: DG-400 powerplant, noise absorbing fairing

: DG-400, all serial no's.

Working instruction no.1 for TN 826-29 Installation of a noise absorbing engine fairing

Sketch 2

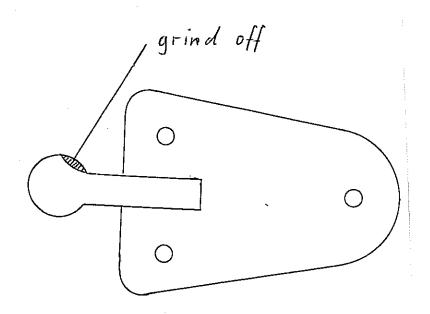
- 3. Move the bracket 4R38/1 (which holds the bowdencable) far enough to the side so that the washer 8.4 DIN 9021 St zn just fits into the edge, see sketch 1.
- 4. Grind away an edge from the left ball which opens the engine door see sketch 2.

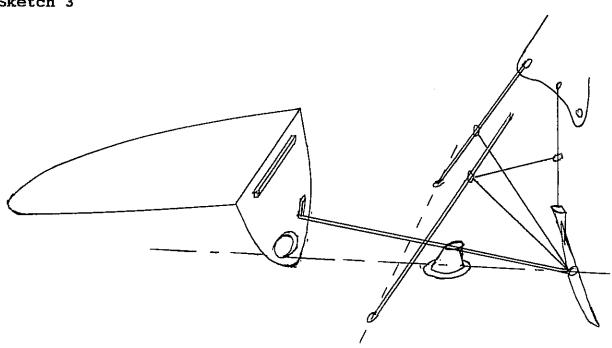
5. Fix the propellerbrake bowdwencable with 6 Ty-Raps to the right engine retaining cable. Distance between ty-raps 70mm (2.8in.). Install a dia. 2mm bungee to the engine retaining cable and to the cable of the rear engine door as shown in sketch 3. The bungee is intended to pull the cables towards the centre to prevent the left cable being jammed between the engine fairing and the cover of the wingflap control.

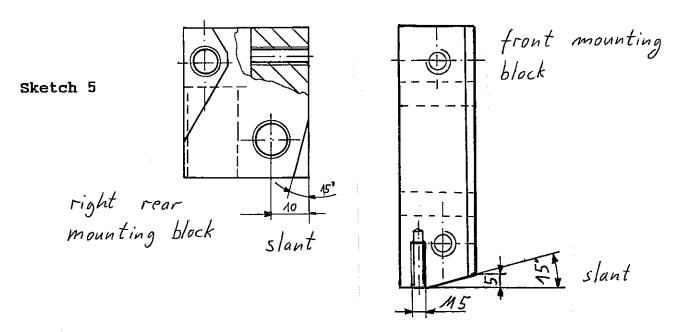
6. Produce a thread M6 in the left rear mounting block for the propeller mounting plate, see sketch 4.

7. Modify the front and right rear mounting blocks for the propeller mounting plates according to sketch 5.

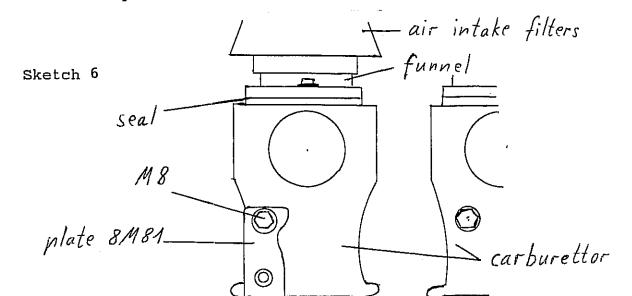
Push the air intake filters over the funnels and fix them with the clamping screws which are part of the filters see sketch 6.
- 9. Install the engine fairing mounting plate 8M81 according to sketch 6. Therefore remove the M8 bolt which fixes the carburettor to the engine and fix the plate with this bolt. Secure the M8 bolt with Loctite 72B and mark with red securing paint.

The torque for this bolt is 22 Nm (16 ft lb).

Sketch 7

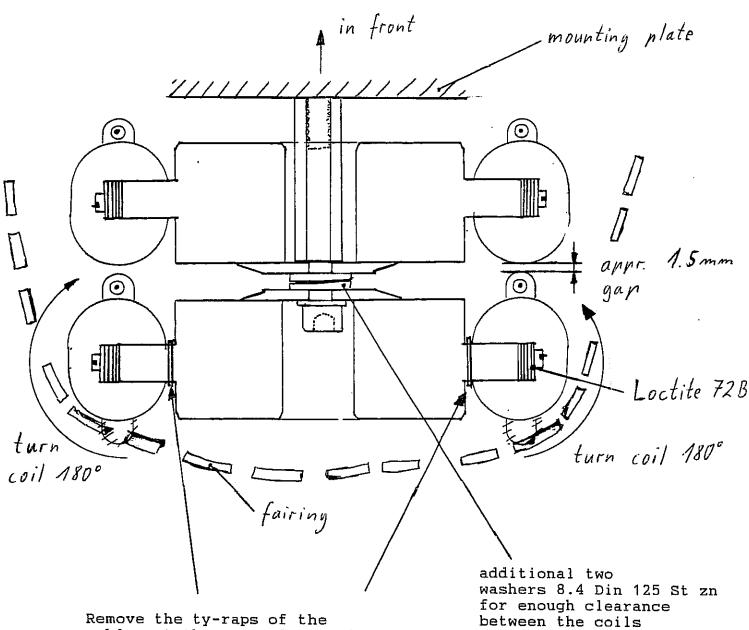
10. With the version with BOSCH-Elektronikboxes the two ignition coils of the rear elektronikbox must be turned according to sketch 7.

Remove the ty-raps of the cables at the rear electronic box.

Fix the cables again in the same way after turning the coils.

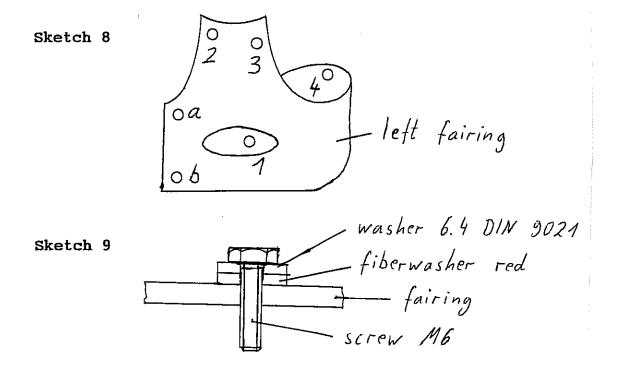
11.Install the left fairing 8Ru99. Work in the order as indicated below, see sketch 8.

Screwed joint 1-3: M6*16 DIN 933 with washers 6.4 DIN 9021 and red fiberwashers 6*18*2mm, see sketch 9
Screwed joint 4: M6*20 DIN 933 with washers 6.4 DIN 9021 and red fiberwashersn 6*18*2mm, see sketch 9

Secure all screws with Loctite 72B and mark with red securing paint.

Sketch 10

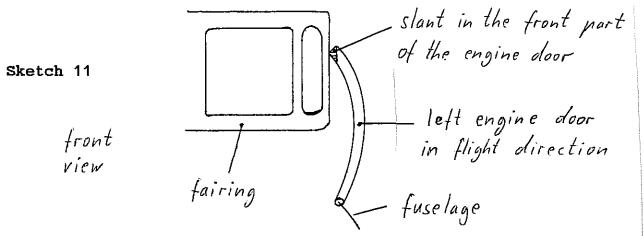
12. Install the right hand fairing 8Ru98 in the given order see sketch 10.

Screws a,b: screws with slotted head M6*20 DIN 963 4.8 zn

with rosette 15*M6 MsNi

Screw c : bolt M6*20 with washers 6.4 DIN 9021 and

fiberwasher 6*18*2mm

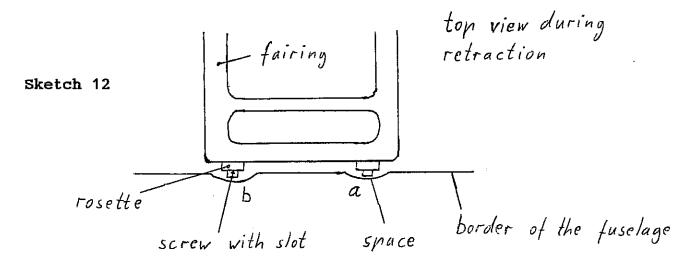
13. Scarf the left engine door according to sketch 11 to prevent the engine door from chafing at the engine fairing.

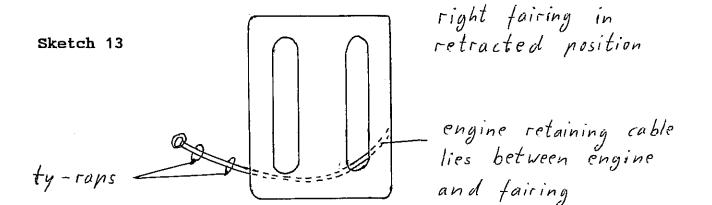
14. Now slowly retract the engine. If screws a and b interfere with the border of the fuselage, you have to grind away from the fuselage accordingly, see sketch 12..
